RE: Addendum #2 to Jackson County RFP 180004, Design/Build Agricultural Facility

1. Addendum #2 is hereby issued to inform all companies that have a copy of RFP 180004, Design/Build Agricultural Facility, of the attached questions and answers from the pre-bid meeting.

Jackson County, GA
Proposed AG Facility
Location

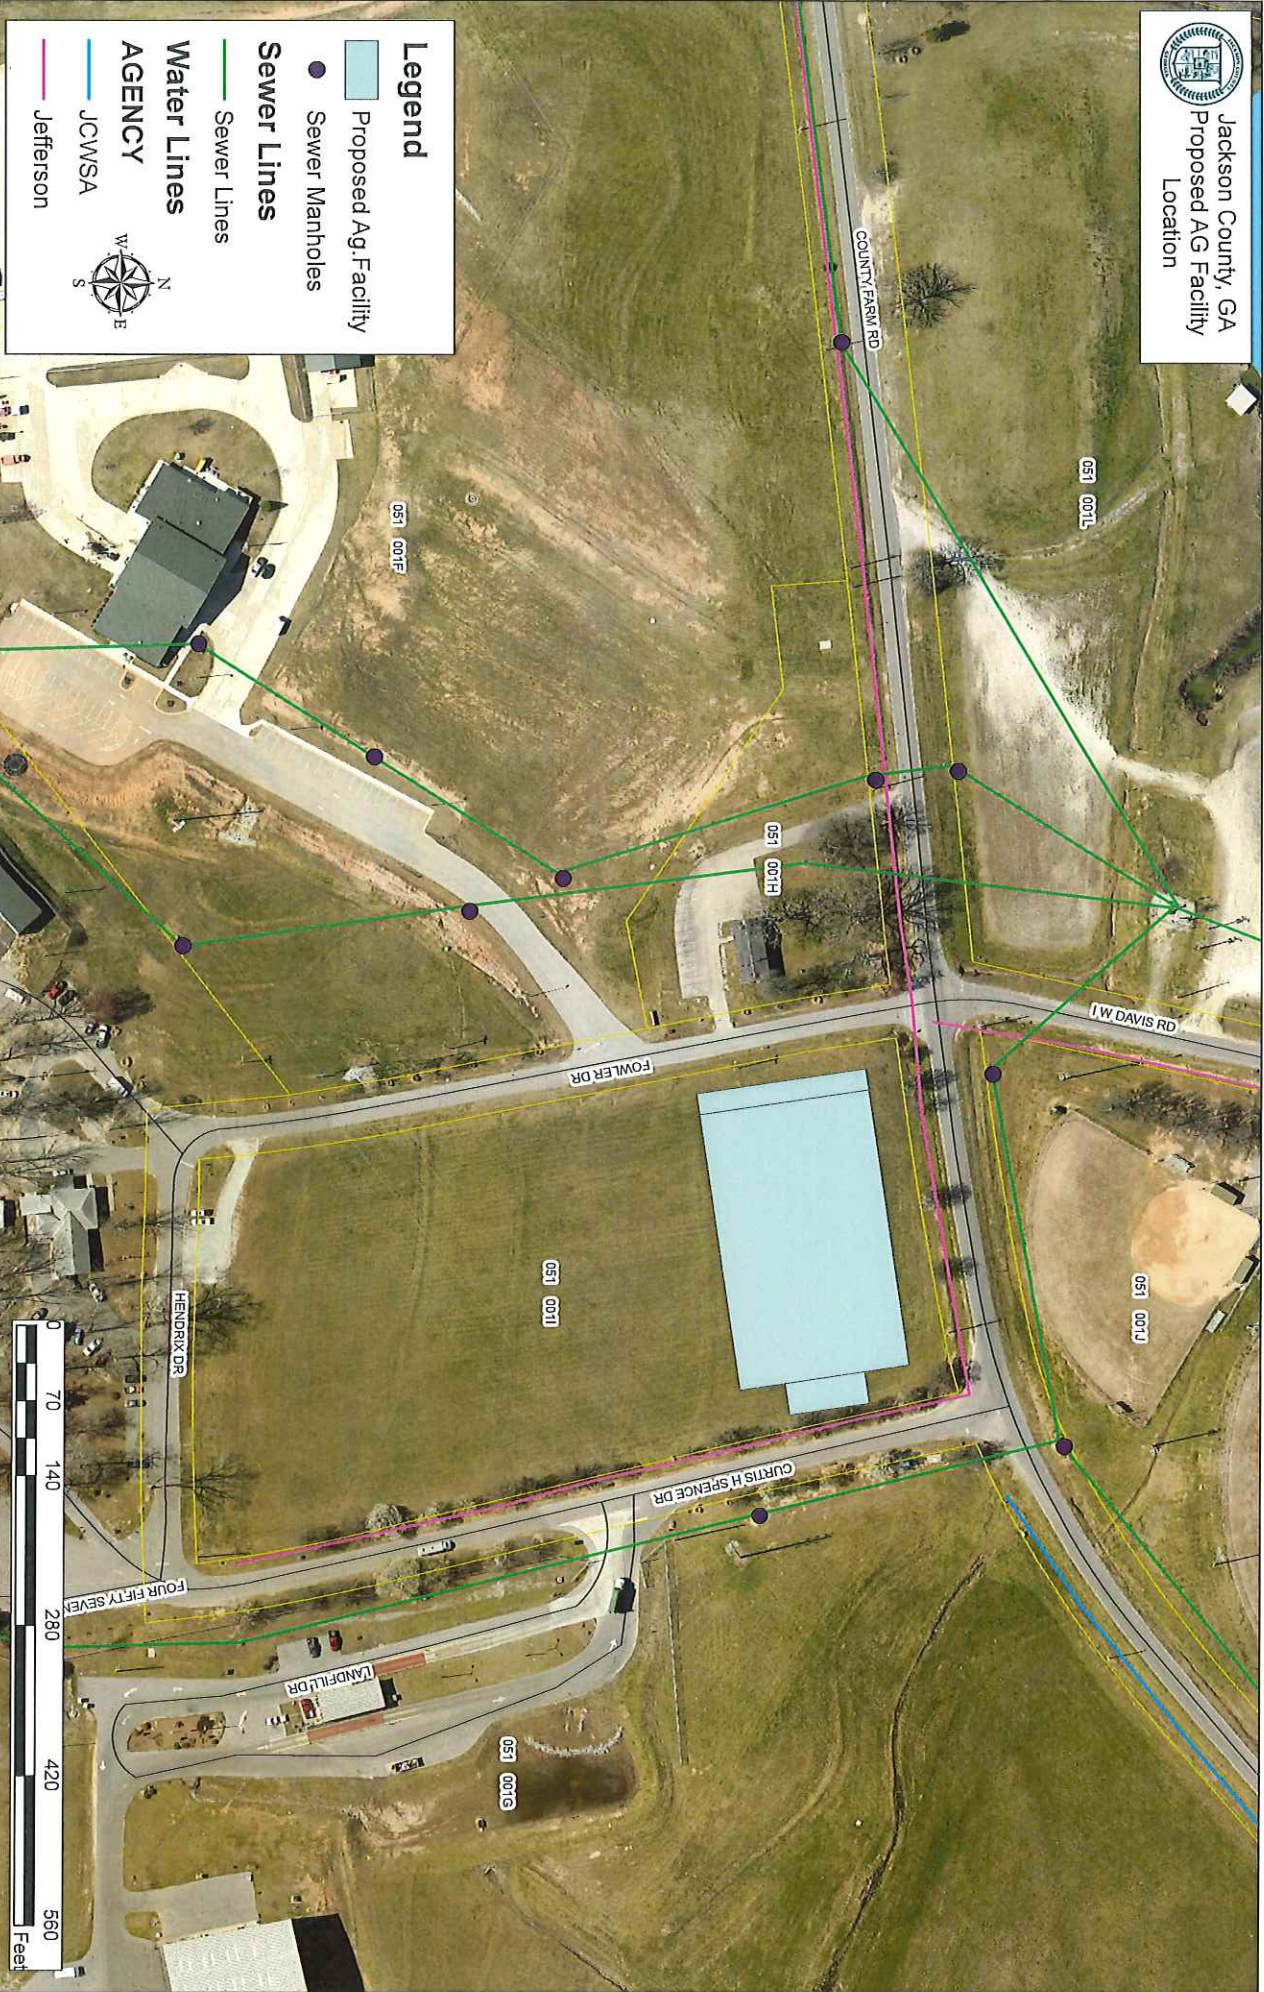
6. Additional questions and answers, and a water and sewer line map of the proposed site are attached.

Prebid RFI-06: a) Is there a survey of the property or do we need to provide a survey plat? Provide survey
b) Are we to provide topo survey and plan for driveway permits and of site utilities? yes
c) Is the project to be served by sanitary sewer and not on-site septic tank drain field system? Sanitary sewer
d) Are we to include soil scientist for on-site system in our proposal? Only if City of Jefferson requires handling the waste a special way before it goes in sewer system
e) Where is this sewer line and how far will it need to be extended? will provide aerial photo showing current location of sanitary sewer line.
